Product Change Notification: PCN-22-137634

SCREW RETAINER KIT

SCREW RETAINER KIT, .135 FLANGE, LOW PROFILE, AMPLIMITE HDF

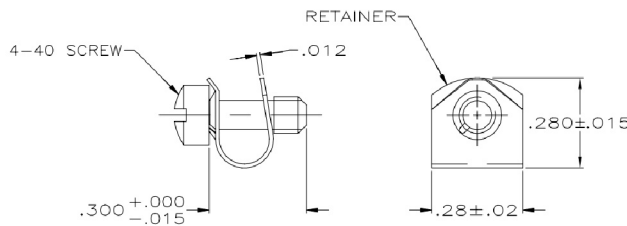
Only one screw head-shape available

Alternate Head-shape

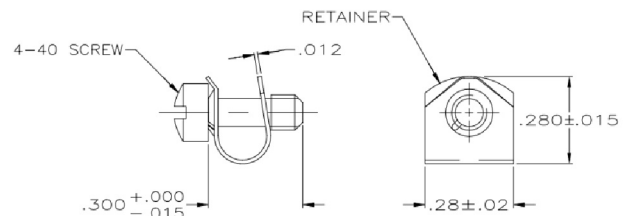
Alternate screw head-shape added
